Re: Mid America Steel, Inc.
Rail Clearance Variance – Mid America Steel
Application
Case No. RR-17-260

1 **RR-17-260** Filed: 6/29/2017 Pages: 2
Request for variance from rail clearance standards

3 RR-17-260 Filed: 7/10/2017 Pages: 2
Response to 5 July 2017 request for additional
information

6 Rail Car Pass-Thru

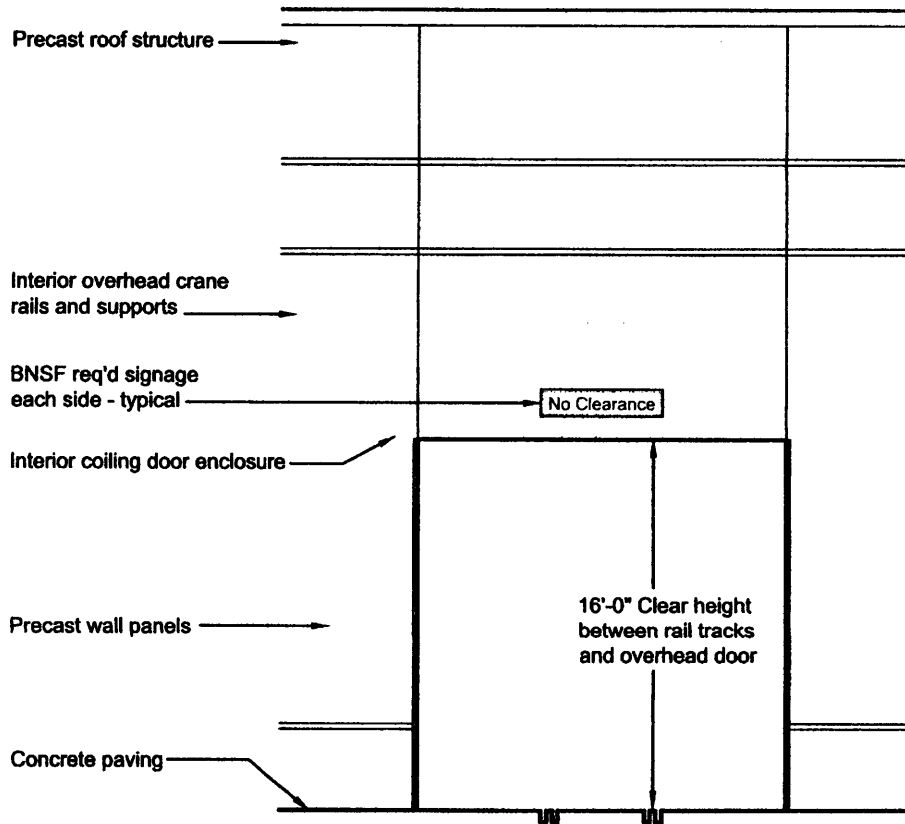
Mid America Steel, Inc. of Fargo, ND hereby applies for a variance from rail clearance standards as prescribed by Section 49-10.1-13 of the North Dakota Century Code. This variance request is due to our overhead doors having 16'-0 clearance from top of rail.

A detail of the rail car pass-thru is enclosed. "No Clearance" signs will be posted above the doorway as shown.

INDUSTRY TRACK EXPANSION
MID AMERICA STEEL, INC.
FARGO, ND
PROJECT OVERVIEW

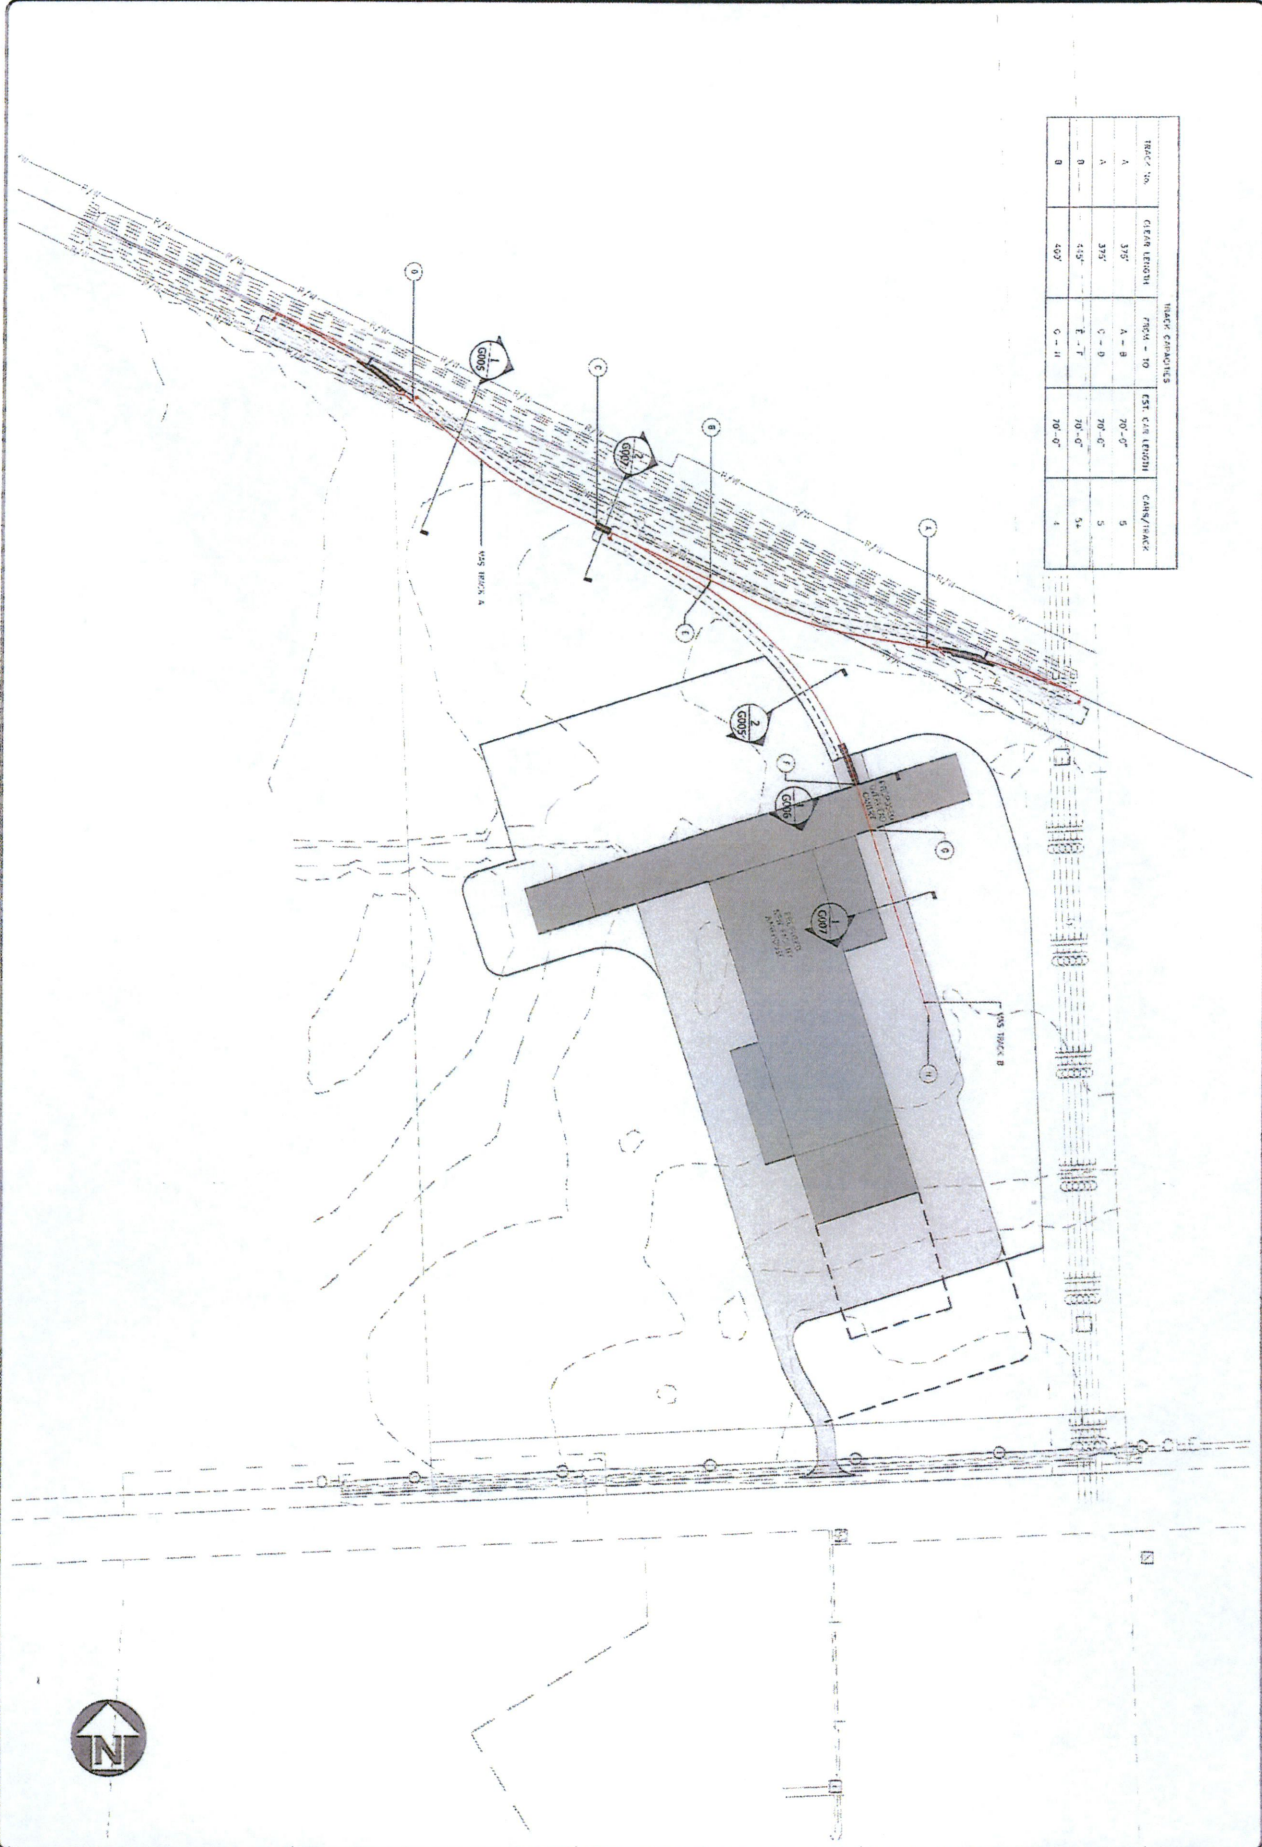
Thank you for your request for variance from NDCC 49-10.1-13 overhead height clearance standards received on Jun 29, 2017. I oversee railroad matters on behalf of the Commission and will be handling your request going forward. After reviewing your request, I noted that there is a reference to multiple doors and that the area is called a "rail car pass through." To eliminate any confusion, can you please provide some additional detail on how many doors there are that require a variance and the name of the structure? An overhead picture or schematic detailing the track and structure it will move through would be greatly appreciated.

You are correct. There are 2 doors. One on the north side and another on the south side of our building. See attached for better clarification. If you have any other questions, feel free to contact myself or Lee.
